RHODE ISLAND DEPARTMENT OF TRANSPORTATION

RHODE ISLAND CONTRACT NO.2015-CH-047

**Improvements to US Route 1 in South Kingstown**

ADDENDUM NO. 1 Prospective bidders and all concerned are hereby notified of the following changes in the Plans, Specifications, Proposal and Distribution of Quantities for this contract. These changes shall be incorporated in the Plans, Specifications, Proposal and Distribution of Quantities, and shall become an integral part of the Contract Documents.

1. Sheet No. 1 Cover

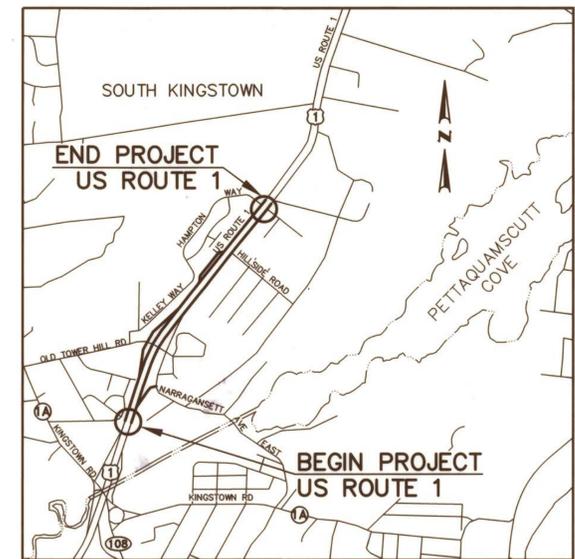
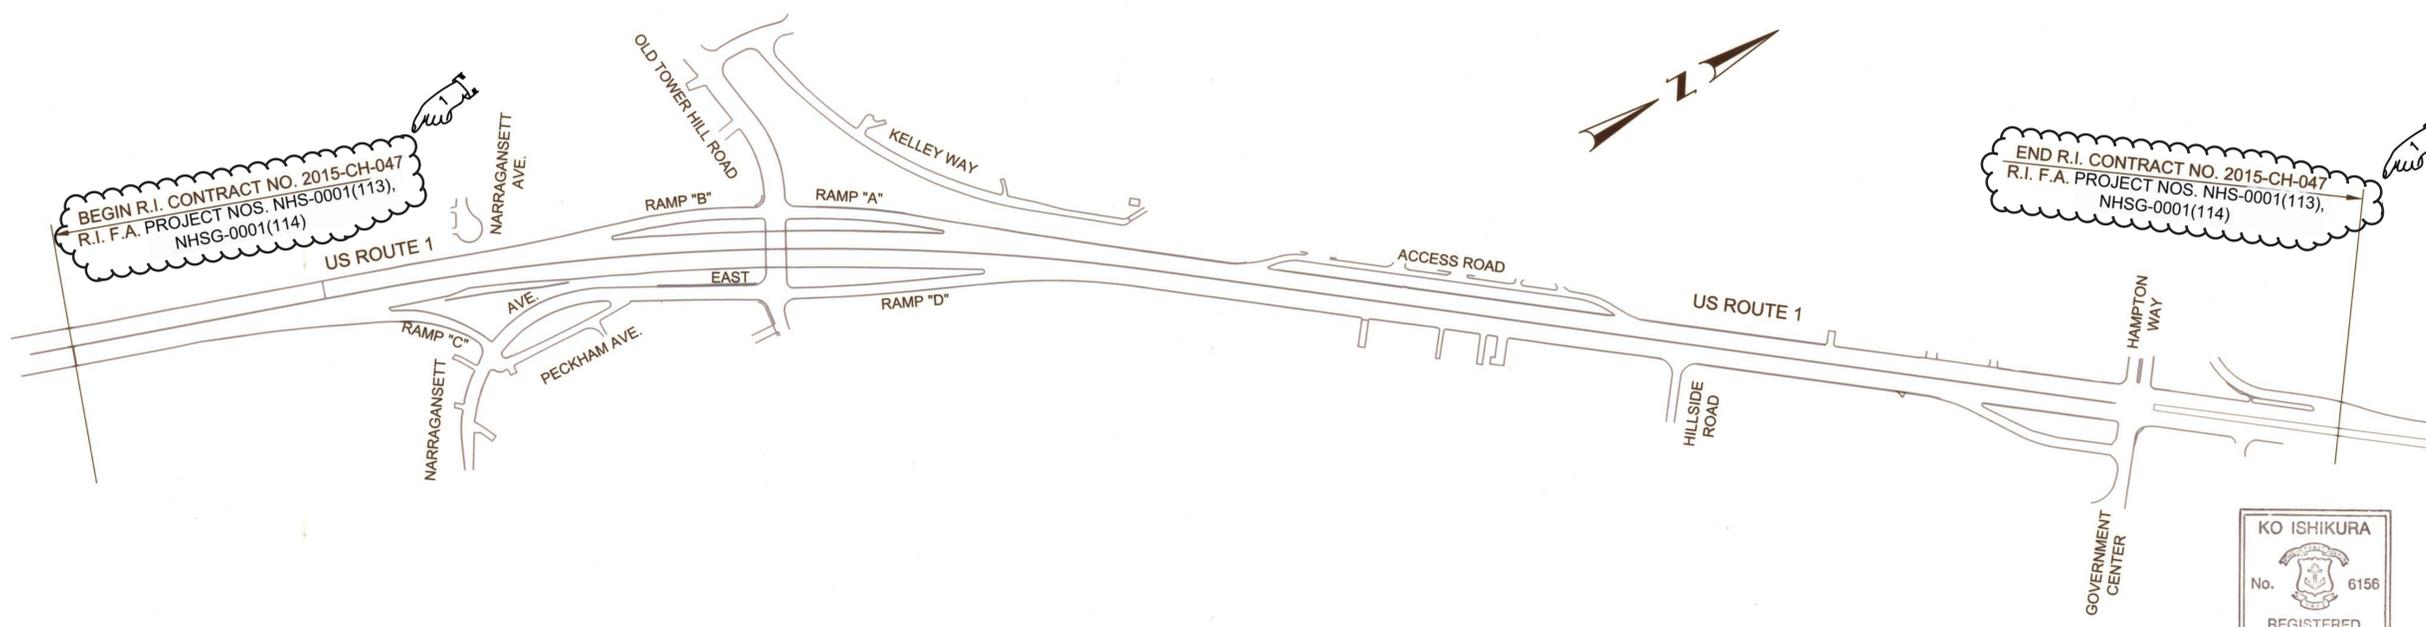
Delete Sheet No. 1 in its entirety and replace with revised Sheet No. 1 (R-1) attached to this Addendum No. 1. The Federal Aid Project Numbers on the layout plan have been revised and Engineer's stamps and signatures have been provided.
